Flight Procedures Cover Page	Task Action: FLIGHT CHECK	Task Type: IAP	Estimated Chart Date: 01/27/2022	APWS Task ID: DE6A54020786453E93C122BE364F08D2	APWS Project ID: 980DC3F897DE4C0CB5C0FF528579E254
Procedure: RNAV (GPS) RWY 13 AMDT 1		Enroute: NO	Specialist: Johnsen, Daniel		Agreement Number:
Airport ID: KDVK			Airport City: DANVILLE		State: KY
Facility ID:	Facility Type:	Flight Inspection Remark Type: New FC Slot			
<p>Procedure Comments:</p> <p>Major amendment using active data for KDVK airport and pending data for runways 13/31; active data for runways 1/19.</p> <p>Runway renumbered to RWY 13/31.</p> <p>Cancels NOTAM LOU 09/049.</p> <p>Contact Jason Kretschmer, AJV-A421, 405-954-4019.</p> <div style="text-align: center;"> <p><i>Digitally signed by</i> JASON KRETSCHMER Oct 28, 2021</p> </div> <div style="text-align: right;">   </div>

FIPC BASIC FORM							
PROCEDURE: RNAV (GPS) RWY 13AMDT 1			AIRPORT NAME: STUART POWELL FLD		AIRPORT ID: KDVK	SPECIAL CONTROL NO: AG-11-019-21	
FAC ID: KDVK13.01		CITY: DANVILLE			ST: KY	ORIG CHART DATE: 01/27/2022	
DFL TYPE: PROC/S	THIRD PARTY: <input type="checkbox"/> YES	EST. TIME ON SITE: 0.4	REIMB. NUMBER:		PTS TASK ID:		
PREFLIGHT NOTES

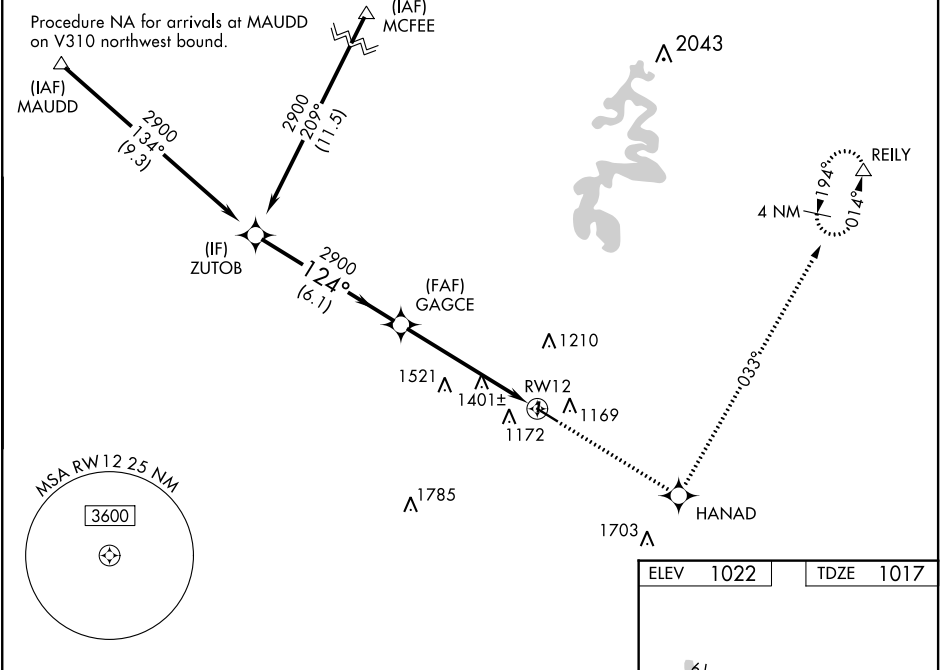
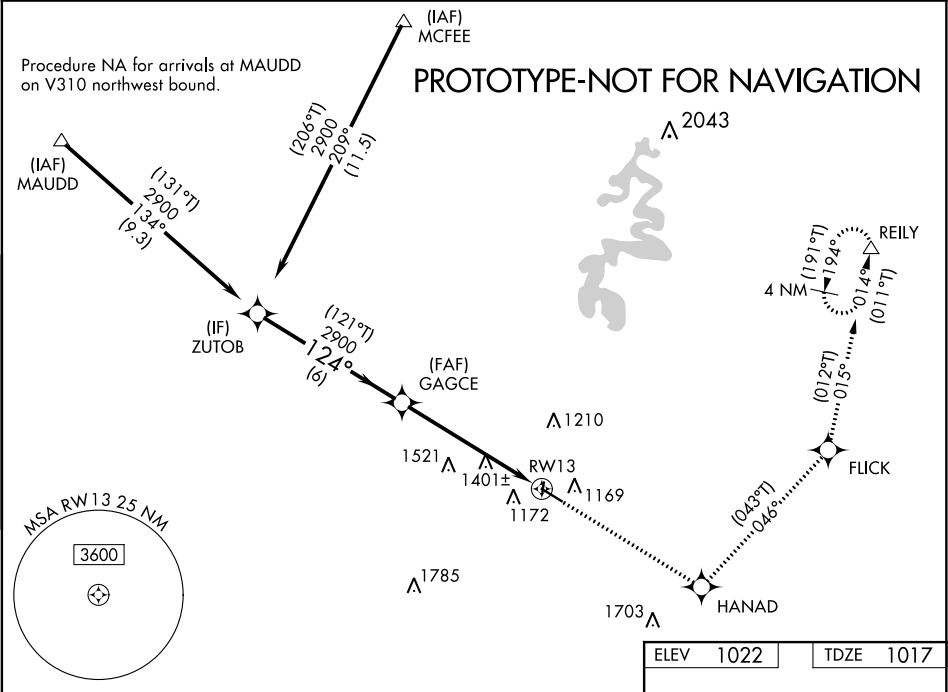
RNP APCH - GPS.	MISSED APPROACH: Climb to 3000 direct HANAD and on track 046° to FLICK then on track 015° to REILY and hold.
▼ Rwy 13 helicopter visibility reduction below ¾ NA.	
▲ For uncompensated Baro-VNAV systems, LNAV/VNAV NA below -17°C or above 54°C.

The airport has renumbered the runways which requires updates to the existing published procedures. During the evaluation of current criteria standards, some changes are necessary for the area navigation (RNAV (GPS)) procedures. RNAV (GPS) for Runway (RWY) 12 requires a less than 90 degree turn in the Missed Approach segment, therefore, an additional waypoint was added to decrease the angle. RNAV (GPS) RWY31 has a precision final approach fix (PFAF) that is too low and will be raised from 2700 to 2900. Additionally, the T-Leg Initial Approach Fix (IAFs) segments are too short and will be extended from 5NM to 7.1NM. In both of these RNAV (GPS) procedures, the minimums may be lowered due to previous tree clearing. The LOC RWY 31 procedure is a minor amendment to change the runway numbering only.
